**PLANNING & ZONING COMMISSION
Special Meeting
Wednesday, February 1, 2017
6:30 p.m.**

TO: Planning & Zoning Commission
FROM: Heather Valone, Village Planner
THRU: Jeffery Stein, Deputy Village Administrator
SUBJECT: Case 14-12 Donegal Excavating PUD
DATE: January 4, 2017

Case No. 14-12
Project Name Donegal Excavating

Re: Donegal Excavating
Case #2014-12
Plan Review #1

ELECTRICAL SITE PHOTOMETRIC PLAN
SCALE: 1" = 100'-0"

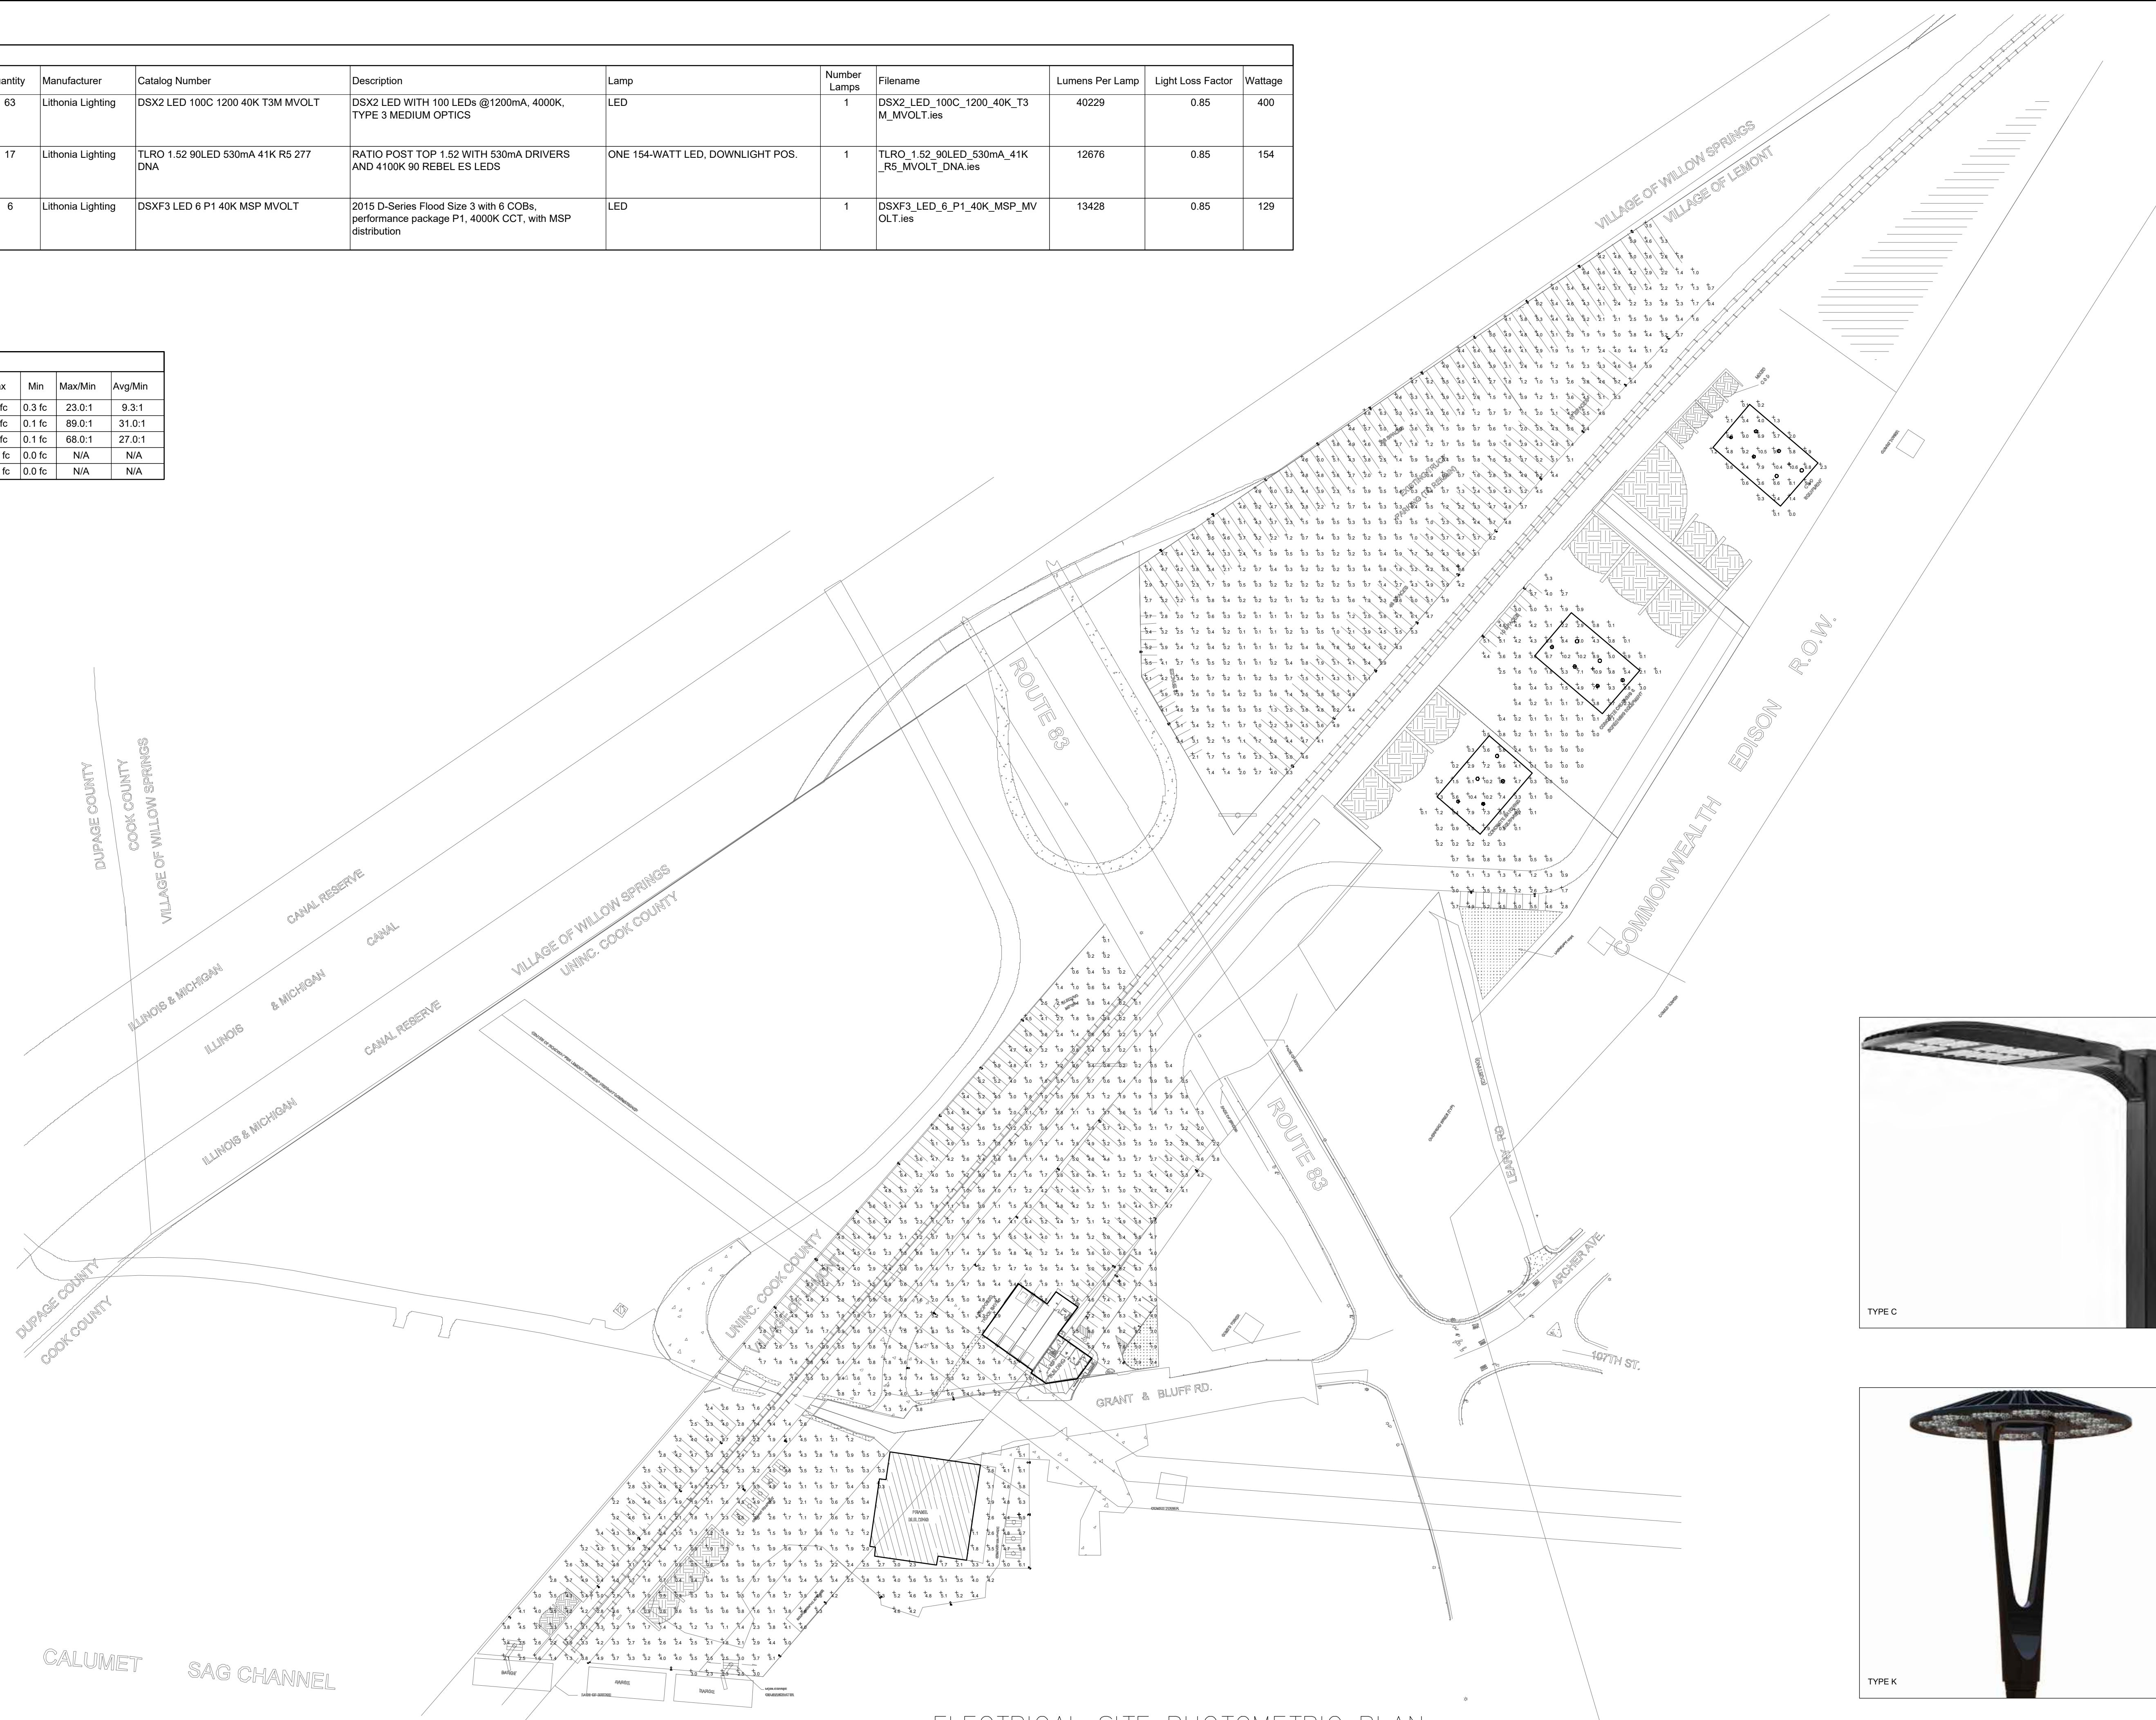
<p>lot landscaping)</p>	<p>be provided on the interior of the parking lot. Each landscaped island shall be a minimum of 9 x 9 feet in size, as measured from back of curb to back of curb.</p> <p>At least one canopy tree shall be installed in each required landscaped island.</p>	<p>area north of the office and truck maintenance building.</p>	<p>truck/equipment parking area. In the event that there is not an opportunity to screen the area from the Route 83.</p>
<p>17.14.010 (Table 17.14.01)</p>	<p>Maximum permissible sound levels for M districts 70 decibels</p>	<p>The applicant did not provide information the proposed sound levels for the concrete recycling, C&DD, and concrete batching uses.</p>	<p>Staff recommends that the applicant provide the information on the proposed sound levels to determine if it meets UDO standards.</p>
<p>17.14.020 (table 17.14.02)</p>	<p>Maximum footcandles at the property line for M Districts five (5).</p>	<p>The applicant is proposing to exceed the UDO maximum.</p>	<p>Staff finds this deviation unacceptable. Staff recommends that the applicant revise the photometric plan to meet the five (5) footcandle requirement at the property lines, extend all footcandle calculations past the property lines, and remove the lighting that is proposed outside of the subject property.</p>

5. The street lighting plan needs to be revised to comply with Village Standards.
 - No flood lights are allowed.
 - Luminaire must be horizontal mount, and because they are LED, have glare shields.

7. Provide information on the proposed sound levels to determine if it meets UDO standards.
8. Revise the photometric plan to not exceed five (5) footcandles at the property lines, extend all footcandle calculations just past the property lines, and remove the lighting that is proposed outside of the subject property.

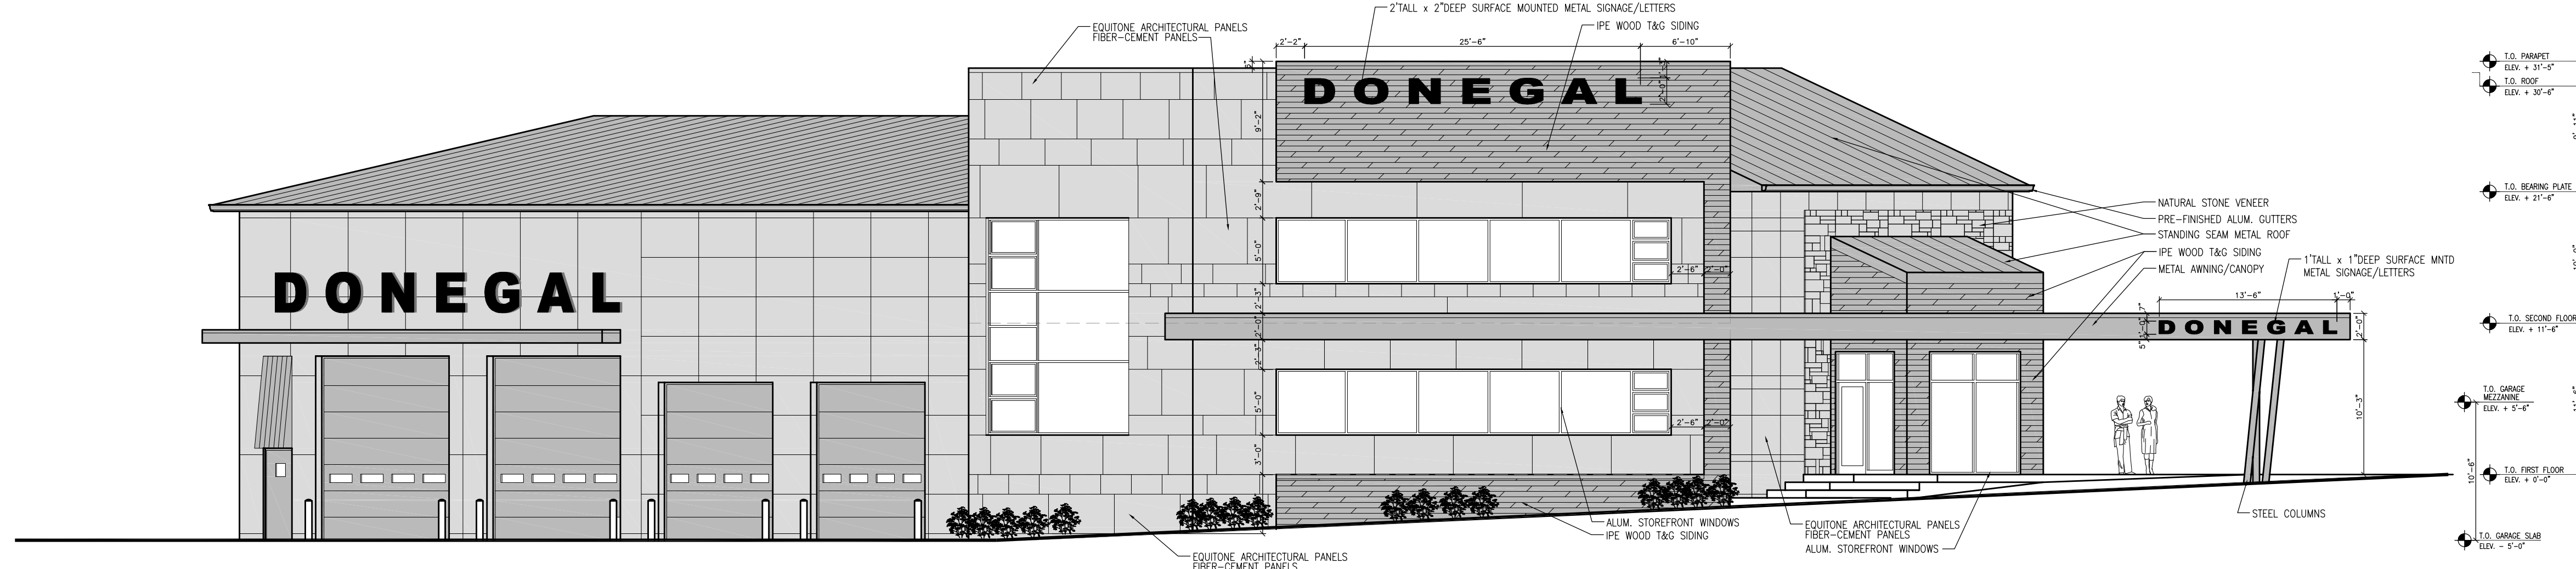
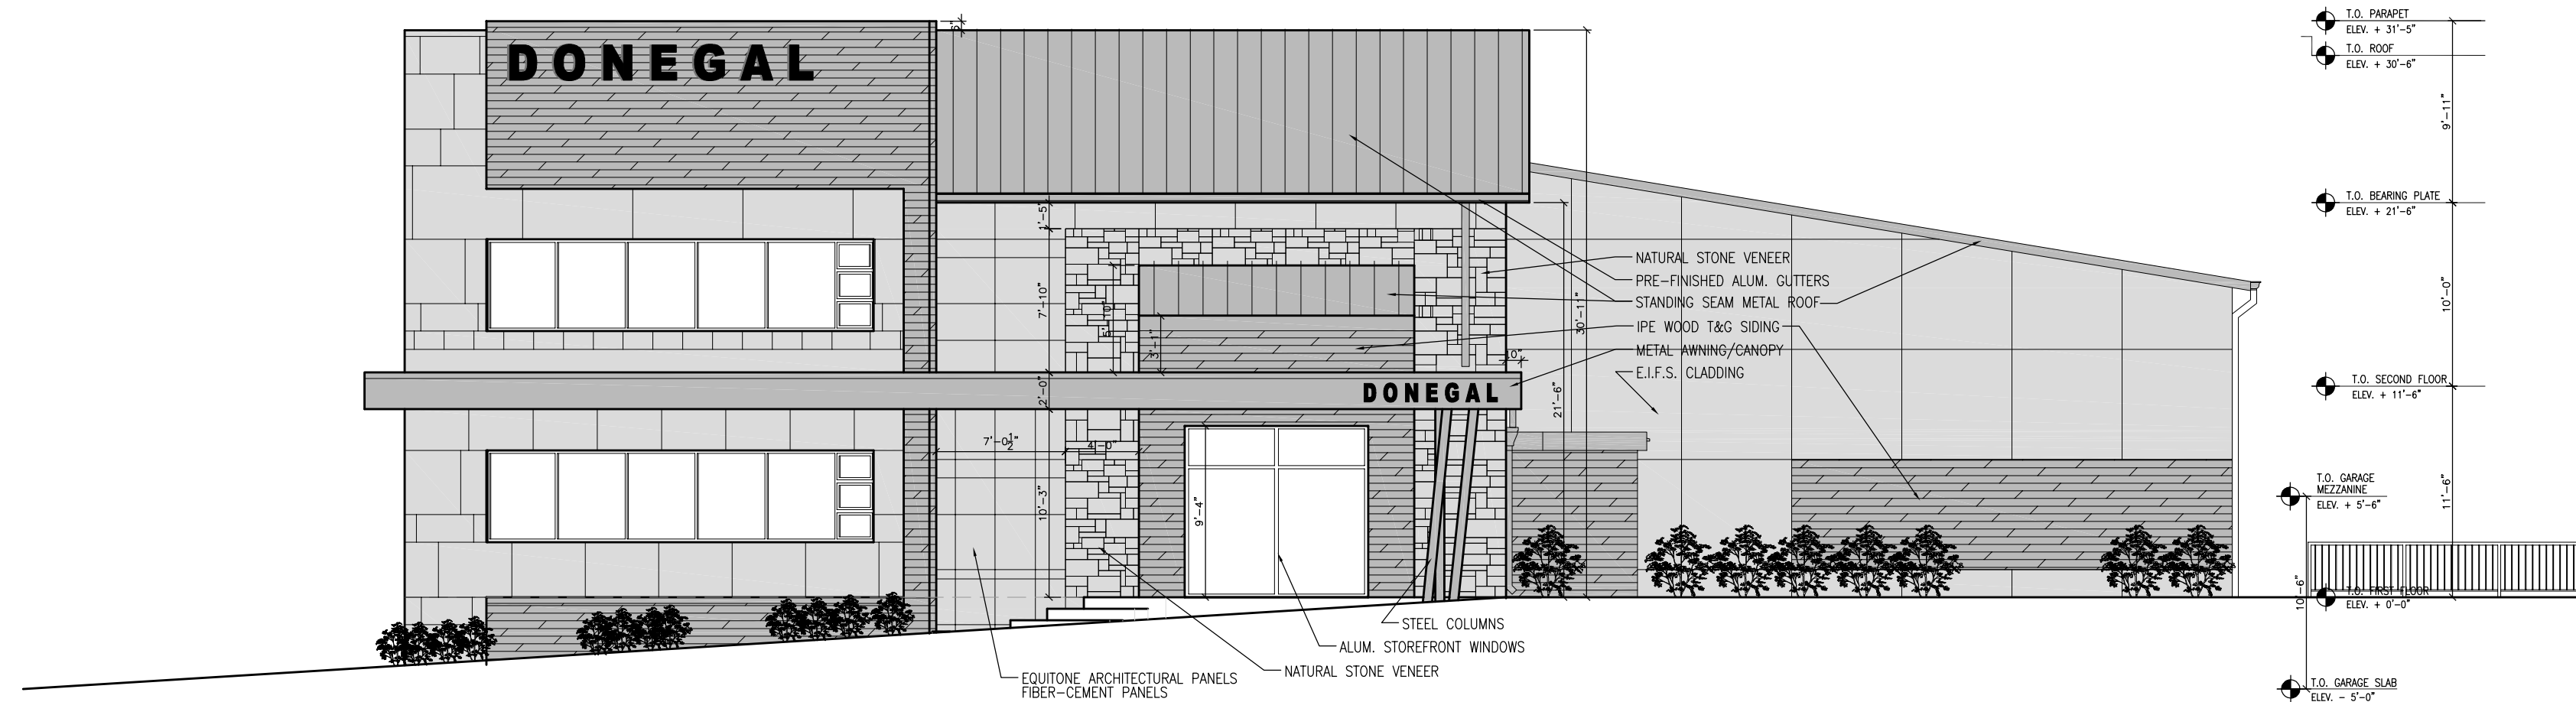
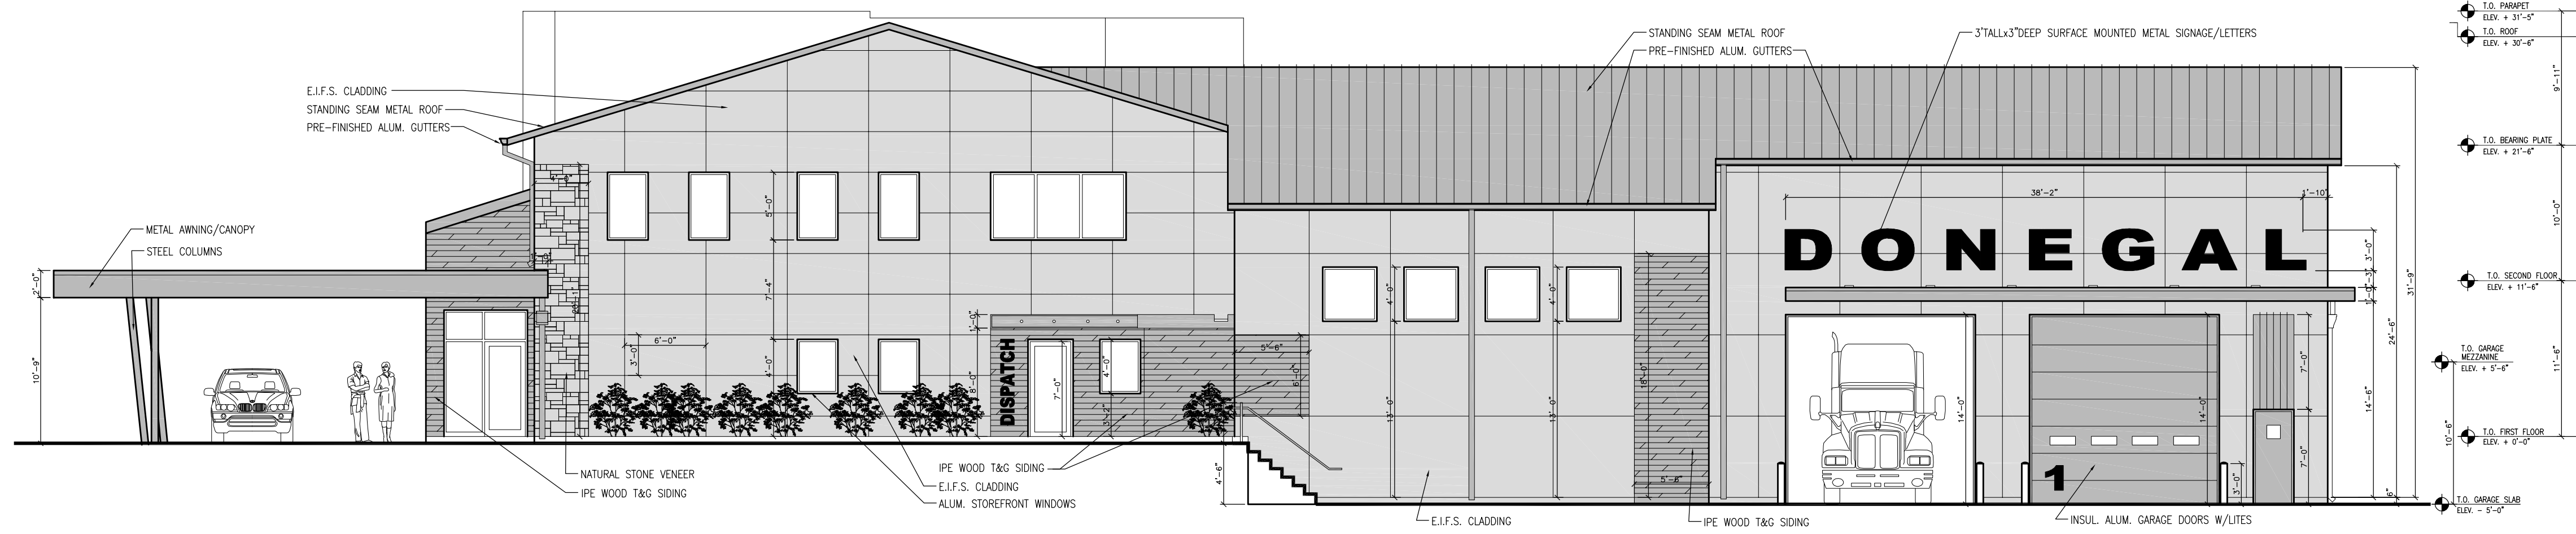
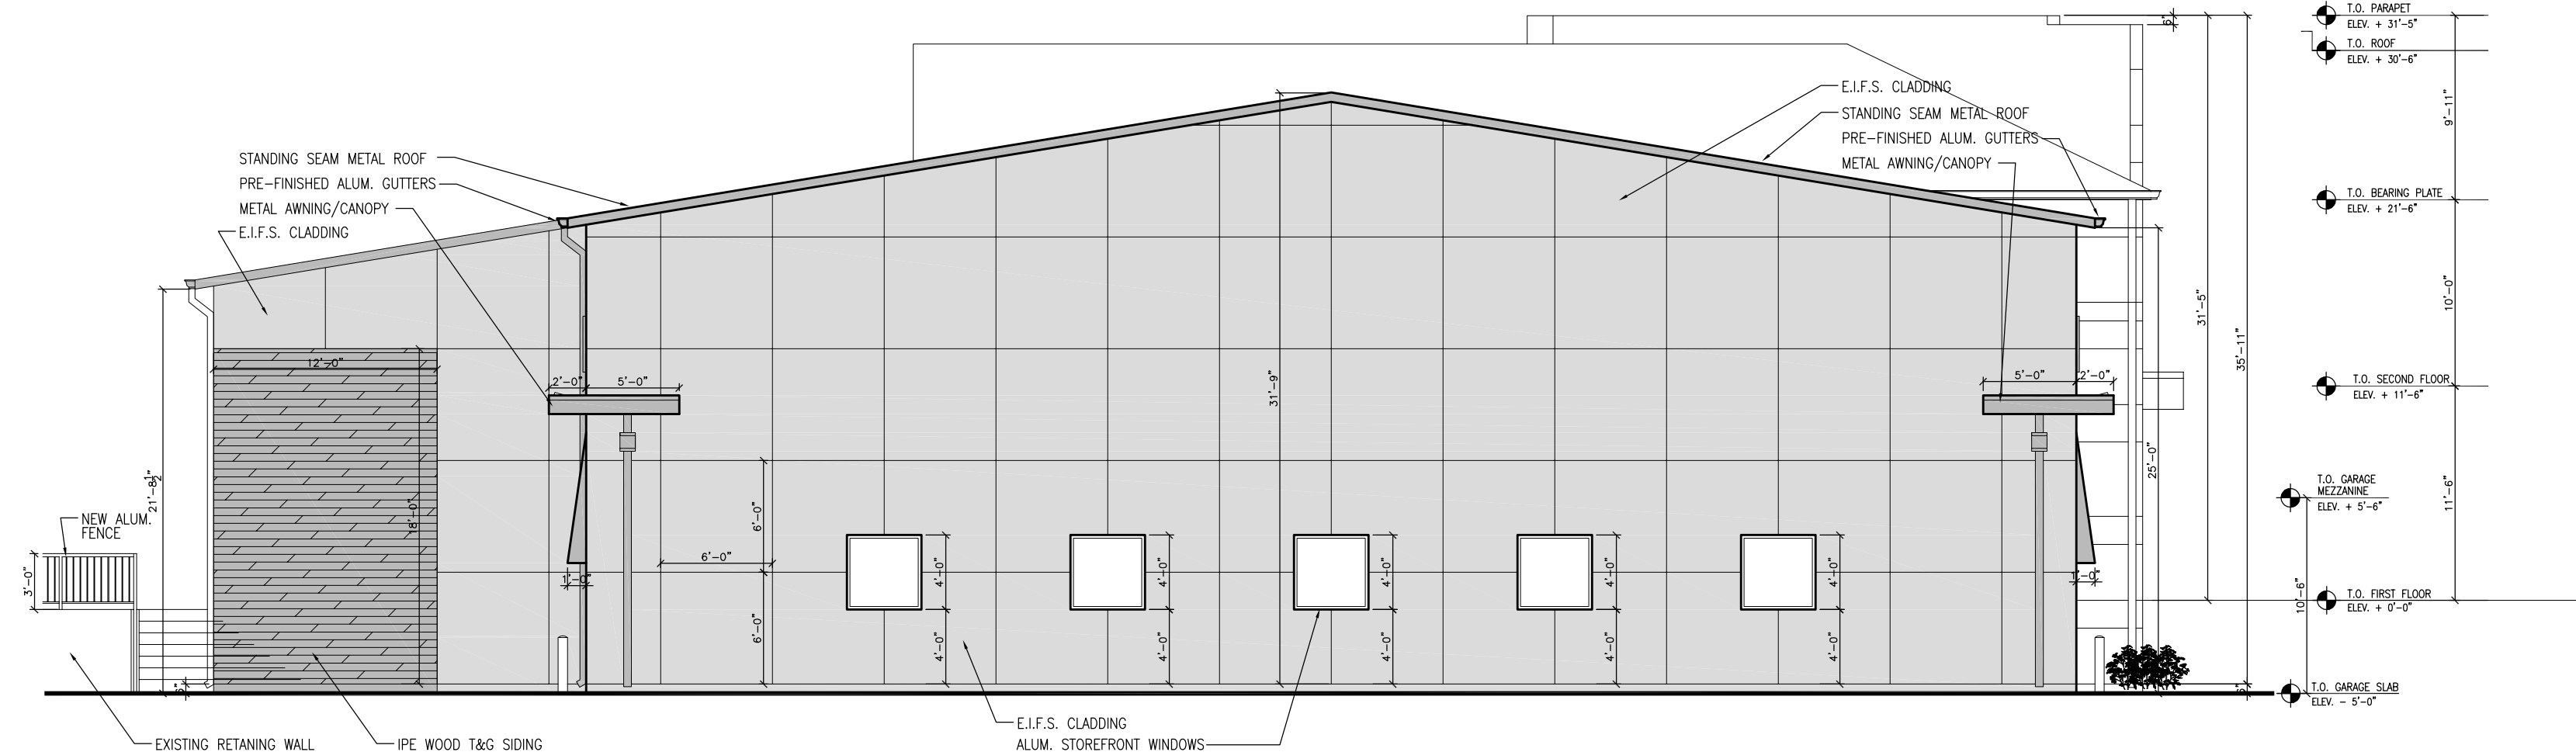
Building Design. The applicant is proposing two buildings and one structure on the property. The applicant is proposing the office and truck maintenance building on Lot 2, on an existing truck wash and repair building on Lot 1, and a proposed equipment storage structure is shown on Lot 1. The proposed office and truck maintenance building generally meets the UDO and the Lemont 2030 Plan standards. However, EFIS is proposed on the truck maintenance portion of the building. EFIS is generally seen as a low quality building material. Staff is recommending that the applicant utilize the fiber cement board that is indicated for the office portion of the building rather than the EFIS. The UDO prevents metal paneling to be used in M-districts. The applicant is proposing a limited amount of metal paneling that attaches the metal canopy for the entrance of the office portion of the building. Staff finds this limited use acceptable as the majority of the metal is for the canopy and not the primary building.

An equipment storage building is indicated on lot 1 west of the existing truck wash and repair building. No information on what will be stored in the building or the appearance of the building has been provided. Staff is recommending that this information be provided to and approved by staff prior to final approvals. The applicant must also provide information that the existing truck wash and repair building is completely located on the subject property. It appears on the landscaping plans and some of the engineering plans, to not be wholly on the subject property.

9. Update the architectural plans to include improvements to south and southeast façade the existing truck wash and repair building on Lot 1.
10. Revised the site plans to show the use of tent membranes to conceal the stockpiling from Route 83.

19. Update the engineering plans to remove truck parking from the 10 ft. utility easement as indicated on the preliminary plat.
20. Revised architectural plans to show no EFIS material on the proposed office and truck maintenance building.
